# Site Accessibility Evaluation

### **Bijou Parking Garage (Enterprise)**

**215 N Cascade Ave  
Colorado Springs, CO  
80903**

SUBJECT: Bijou Parking Garage Self-Evaluation

### Finding: 1

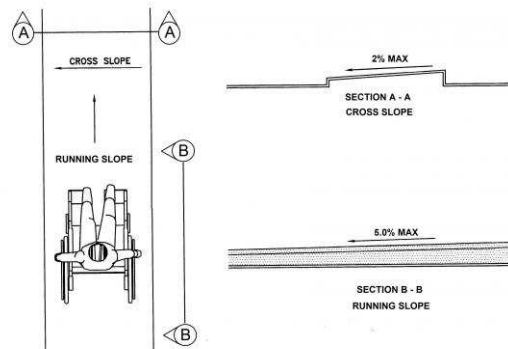
The accessible route contains running slopes greater than 5 percent and cross slopes greater than 2 percent.

Near the main entrance to the garage is a section of sidewalk with up to 5.5% cross slope and up to 4% running slope.

The running slope can match road grade, but the cross slope should not exceed 2%. Remove and replace this section of sidewalk.

**Finding: 2**

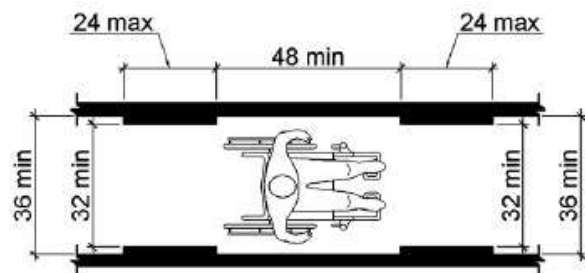
The route of travel at this location does not provide a minimum width of 36 inches. The space between the wall and barrier is 36", but the base plates of the barrier reduce the width to 34" or less.

The route between the office wall and the barrier fence is not wide enough.

Consider moving the barrier 2" farther toward the drive aisle, or redesign the base plates so they do not interfere with the clear width.

**Finding: 5**

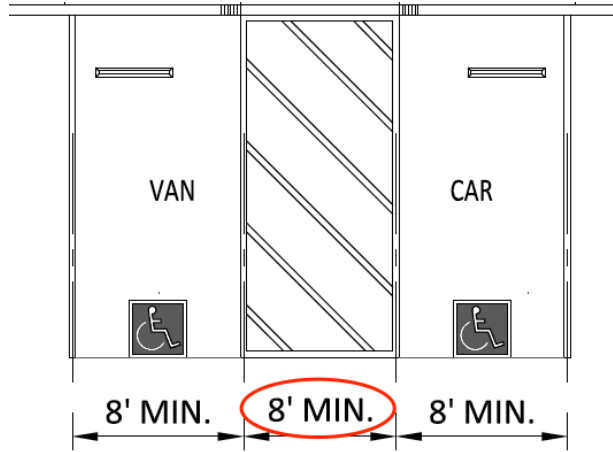
The access aisle is not a minimum 8 feet to the centerline of the stripe.

The access aisle for the van accessible spaces is only 7'-9" wide.

Restripe the aisle to 8'-0" wide.

**Finding: 6**

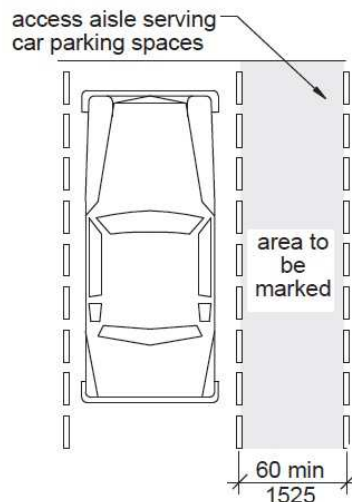
The access aisle is not a minimum 5 feet wide.

The access aisle for the car accessible spaces is 4'-9" wide.

Restripe the access aisle to 5'-0" wide.

**Finding: 8**

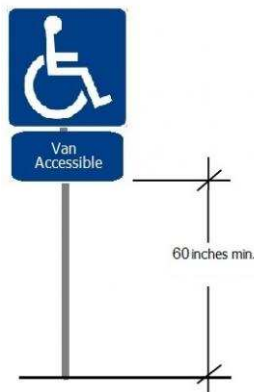
The parking sign is mounted too low.

The van accessible signage is mounted at 54-1/2" to the bottom of the sign.

Increase the height of the sign to 60" to the bottom.

**Finding: 9**

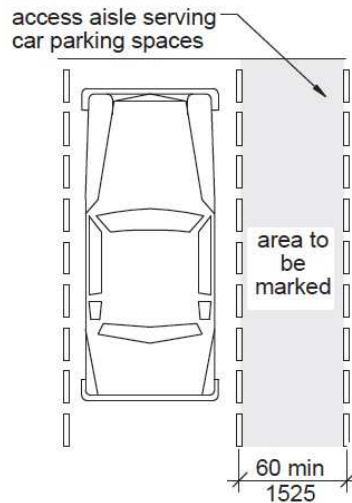
The access aisle is not a minimum 5 feet wide. The adjacent parking space is 8'-4", so there is adequate width to provide a compliant access aisle.

The access aisle is 4'-8" wide.

Restripe to provide a 5'-0" wide access aisle.

**Finding: 10**

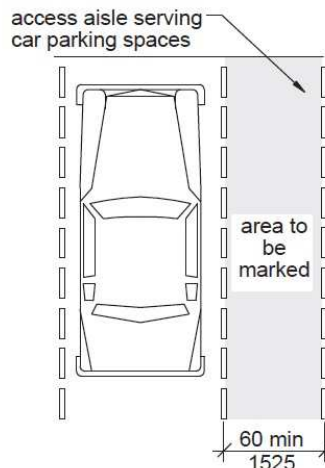
The access aisle is not a minimum 5 feet wide. The accessible space on the left is 9'-10" wide, and the space on the right is 8'-5", so there is adequate space to provide compliant access aisle and parking spaces.

The access aisle is only 4'-7" wide.

Restripe to provide a 5'-0" wide access aisle.

**Finding: 11**

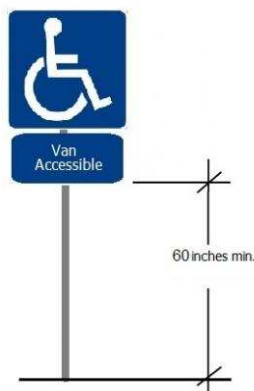
The parking sign is mounted too low.

The accessible parking signage is mounted at 52-1/2" to the bottom edge.

Increase the height of the signs to 60" to the bottom of the signs.

**Finding: 12**

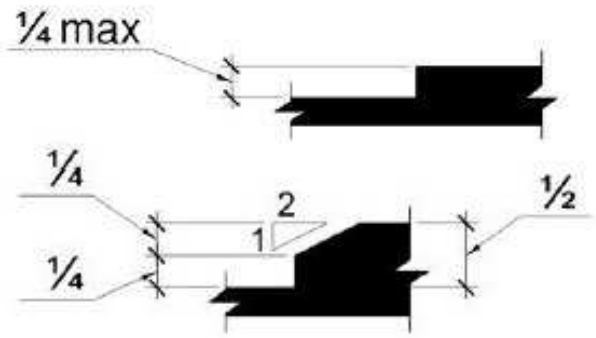
The walkway contains abrupt vertical edges and/or variations over a 1/4 inch.

The concrete at the entrance to the elevator is failing.

This facility was revisited in June 2019 and the concrete topping has deteriorated further.

Remove and replace the topping.
